RE: **Lot 13 Block 6 Volcano Cliffs Unit 18 SAD 228**
8011 Alto Rey Ct. NW
Grading and Drainage Plan
Engineers Stamp Date 10/29/2020 (D10D003N4)
Pad Certification Dated: 11/03/2021

**Re: Pulte at Volcano Cliffs Unit 18
Erosion and Sediment Control Plan
Engineer's Stamp Date 6/17/2021 (D10E003_P)**

GRADING AND DRAINAGE PLAN

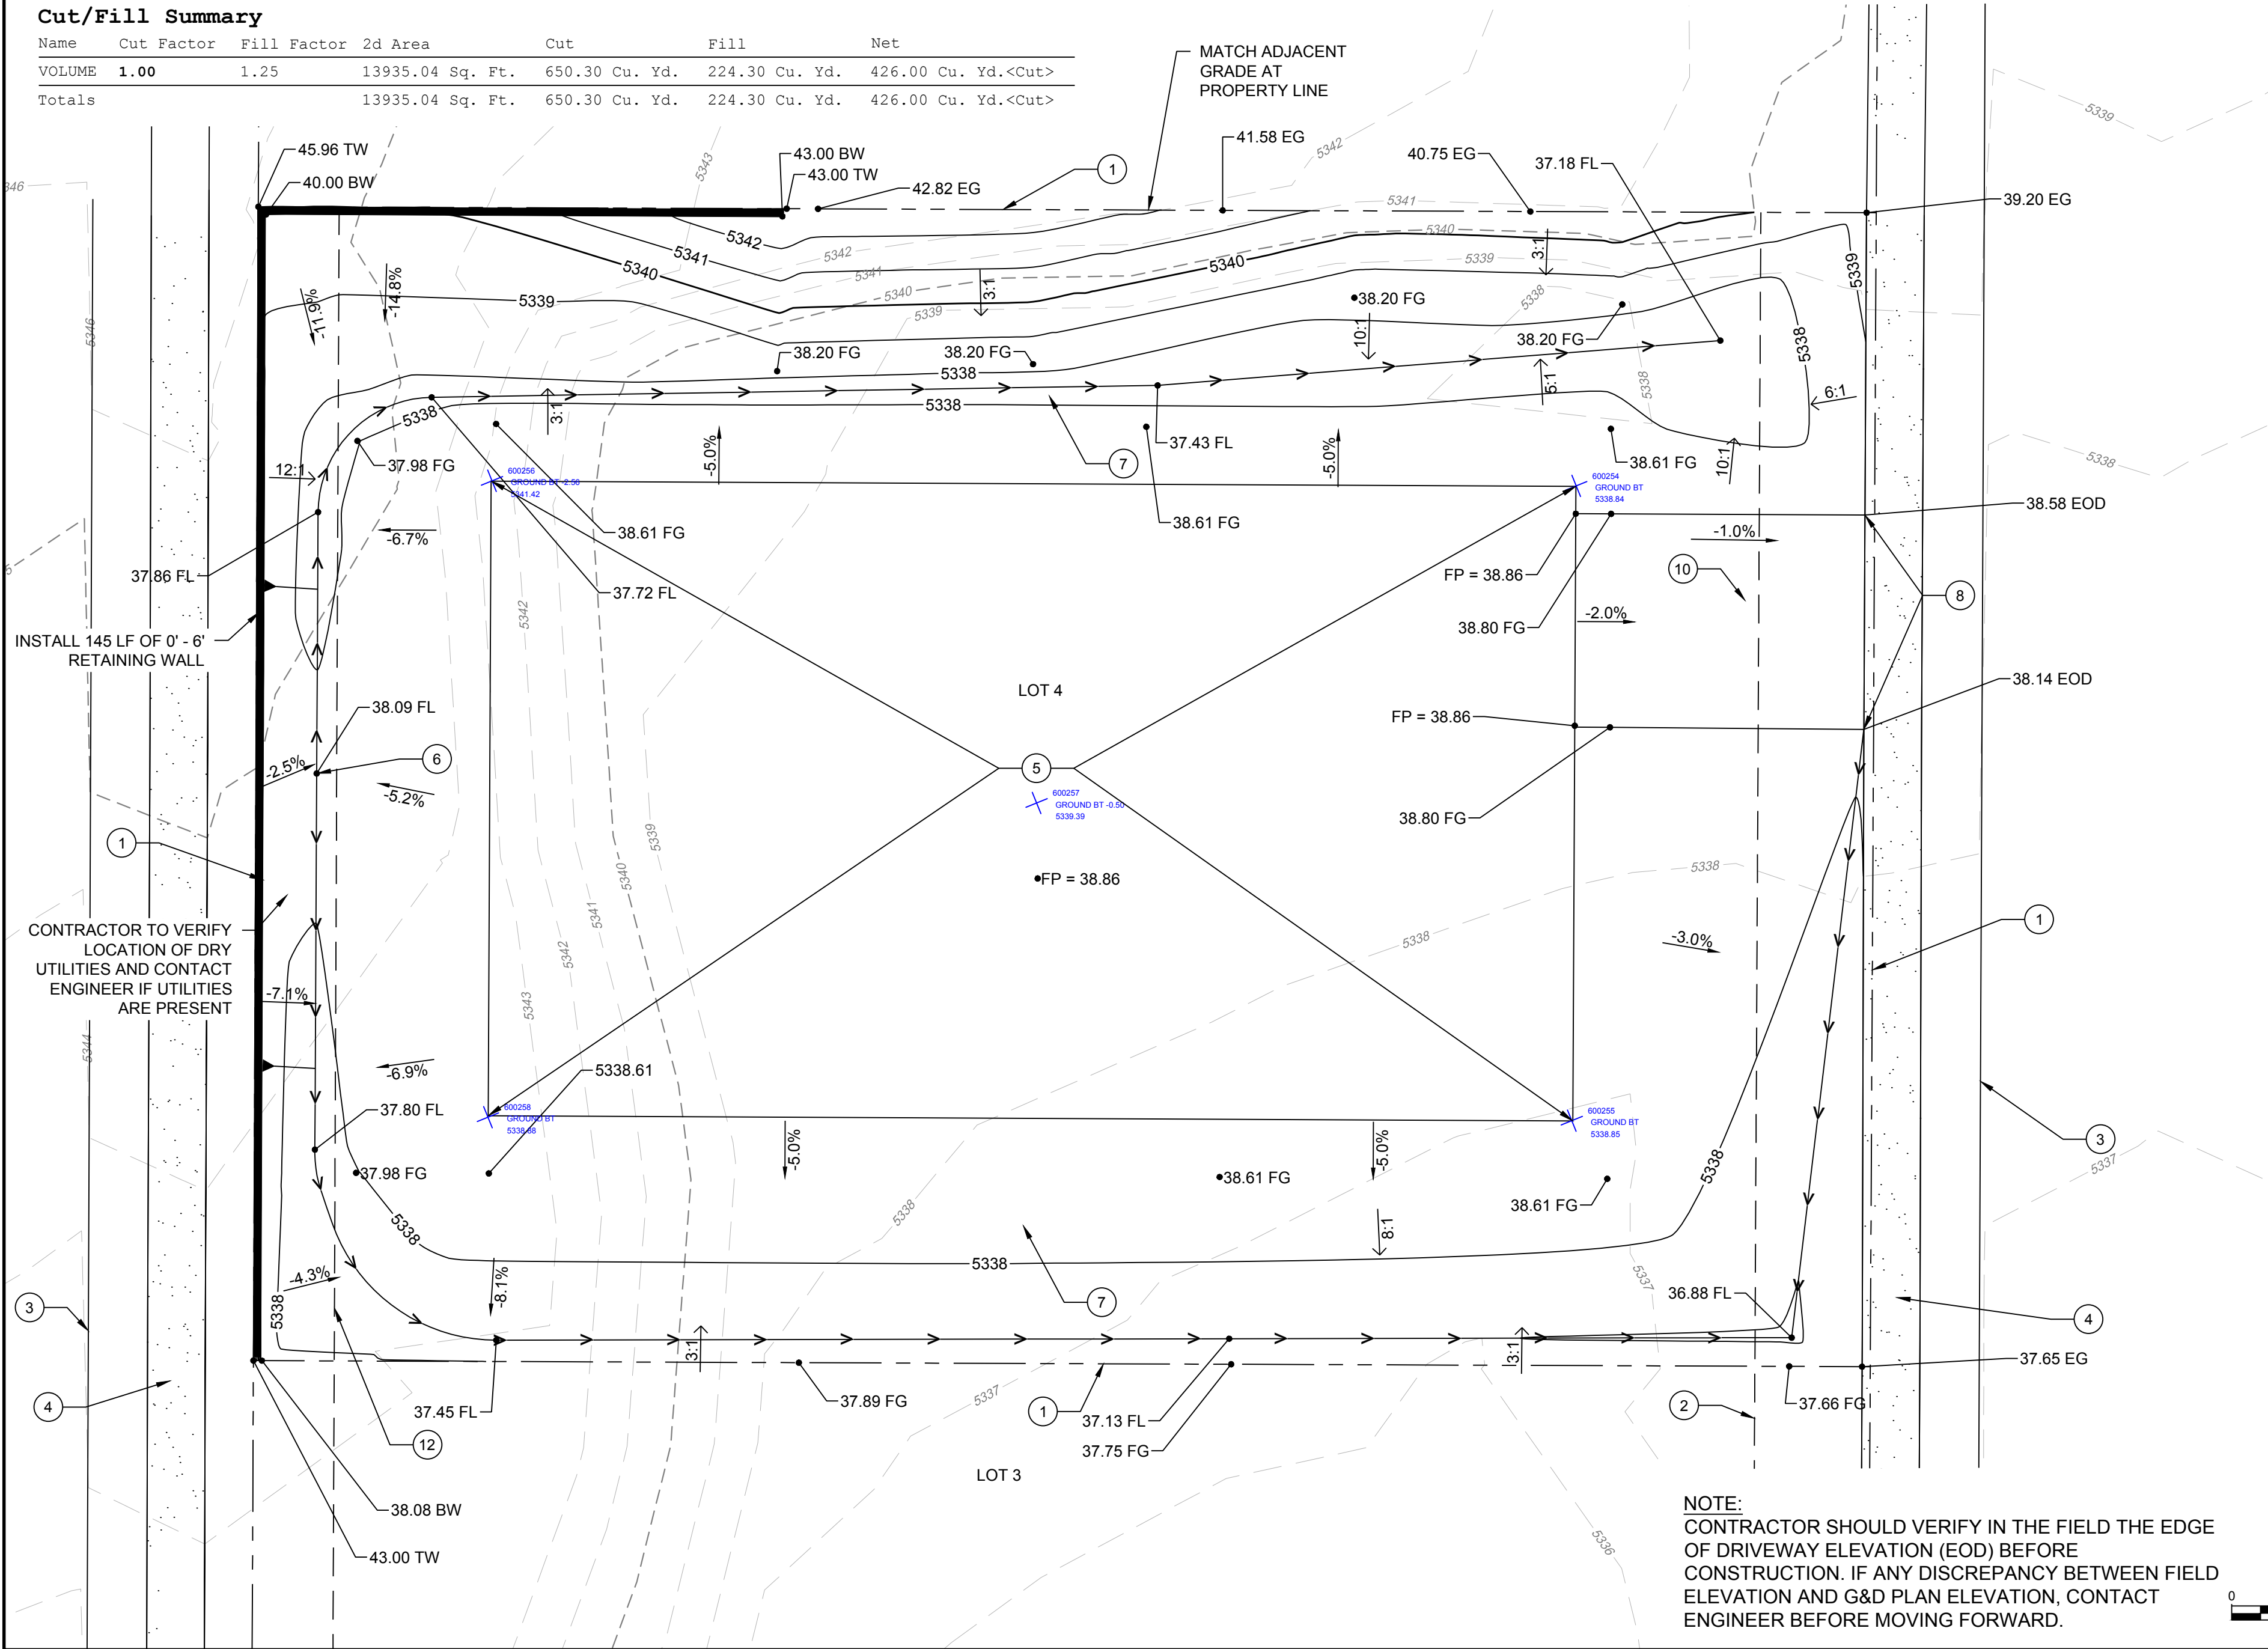
Based upon the information provided in your submittal received 11/4/2021, this plan is approved for Building Permit.

Reiterate to the Owner/Contractor that a separate permit for a garden/retaining wall must be obtained with the approved G&D plan and Pad Certification. **Also, if a swimming pool is to be placed the grading and drainage plan will change and will need to be resubmitted showing location of pool and land treatment changes.**

Prior to Certificate of Occupancy release, Engineer Certification per the DPM checklist will be required.
